Natural Resources Wales permitting decisions

Atlantic Recycling Limited

Decision Document

The variation number is: EPR/PP3993VS/V007.

Cross section plan of proposed SWCP:

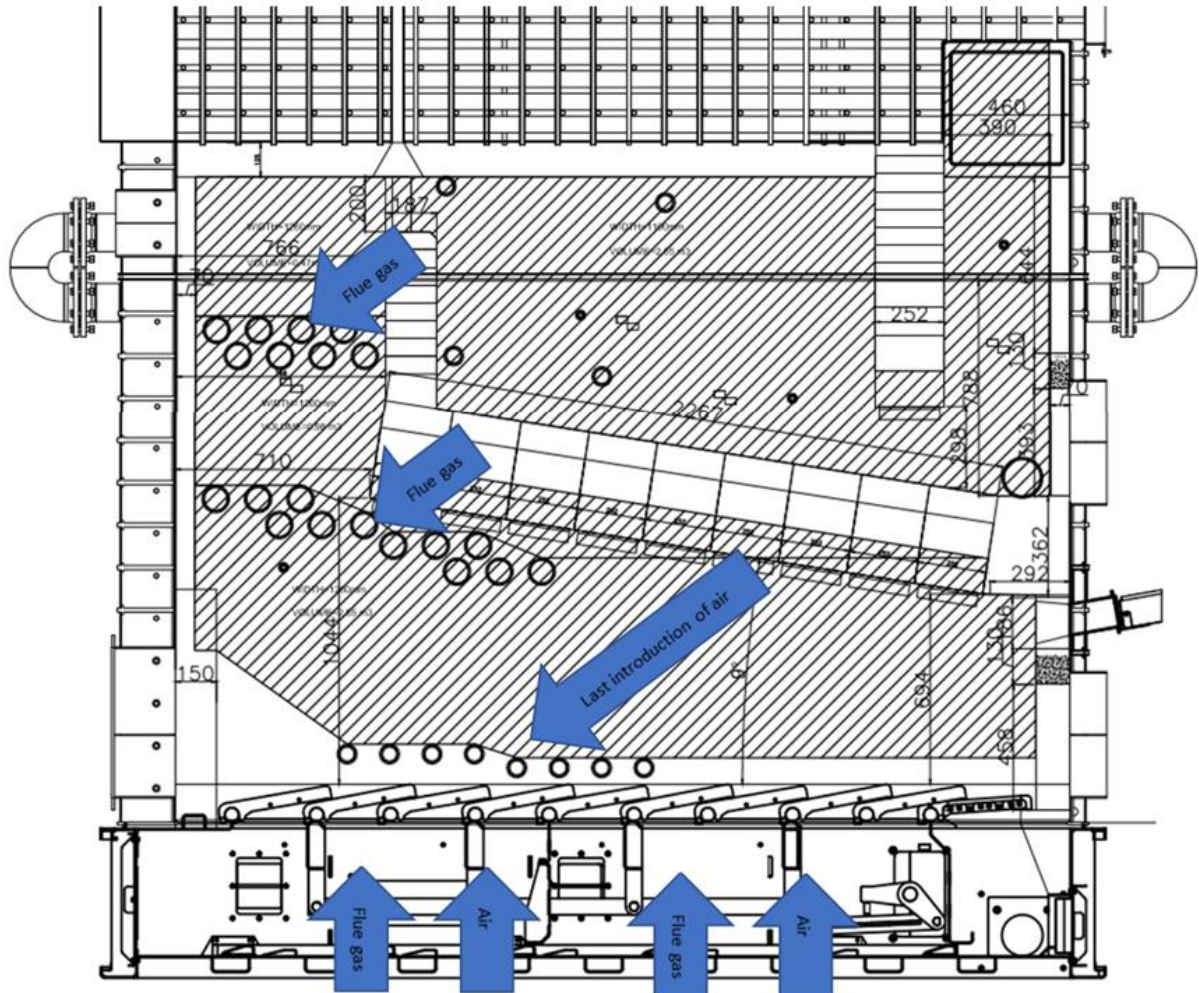
The operator supplied a scale cross-sectional drawing of the boiler on 3 June 2020, with labels describing the air inputs and a hatched area showing what they describe as the secondary combustion zone. The operator maintains that the last input of air is located very close to the base of the chamber as can be seen on their diagram below. The plan (reproduced below) shows a small internal volume to be occupied by the wood fuel itself and then the entire

remaining internal capacity as being the secondary combustion zone. The zone occupied by the wood fuel in the drawing isn't labelled as such but can be seen as an unshaded white area below the hatched area.

The drawing also shows additional inputs that it describes as flue gas. As can also be seen on the diagram below, the first of these is located significantly far into the hatched area and the second is further still into the hatched area.

The details provided show that primary combustion and gas phase combustion will be occurring in the space above the grate, however the applicant has declared that the starting boundary of the QSCZ starts at the top surface of the waste wood fuel, leaving no additional space for the primary combustion zone.

The information provided fails to prove that the stated QSCZ is correct, and that the zone does not in fact start further into the chamber such as where the drawing indicates that Flue Gas (and potentially additional combustion air) is added.

In order for a specified volume within a waste co-incinerator to be classified as the QSCZ, it must meet the necessary criteria. The QSCZ specified in the application includes a significant volume above the fuel grate where these criteria will not be met. Specifically, primary combustion must have been completed, gas phase combustion should be completed, and the last input of combustion air must have taken place. **These criteria are not met by a substantial proportion of the volume that has been categorised as the secondary combustion zone by the applicants. Consequently we do not consider that the proposed SWCP has been shown by the applicant to meet the necessary 2 seconds of flue gas residence time standard in a clearly identifiable discrete secondary combustion zone and therefore cannot permit this element of the application.**

Furthermore, applications should demonstrate that the flue gas achieves the minimum temperature requirement of 850°C for 2 seconds. This is typically demonstrated by submission of a computational fluid dynamics (CFD) modelling report. No such report or alternative demonstration has been provided by the applicant.

Achieving the minimum flue gas temperature requirement of 850°C for 2 seconds of residence time in a secondary combustion zone is a fundamental requirement for maximising the destruction of persistent pollutants in modern waste incineration and co-incineration processes. The applicant has not demonstrated that the proposed SWCP will achieve the requirements and the information provided suggests that the

requirements cannot be met. We therefore conclude that we must refuse permission to operate the SWCP as currently designed.
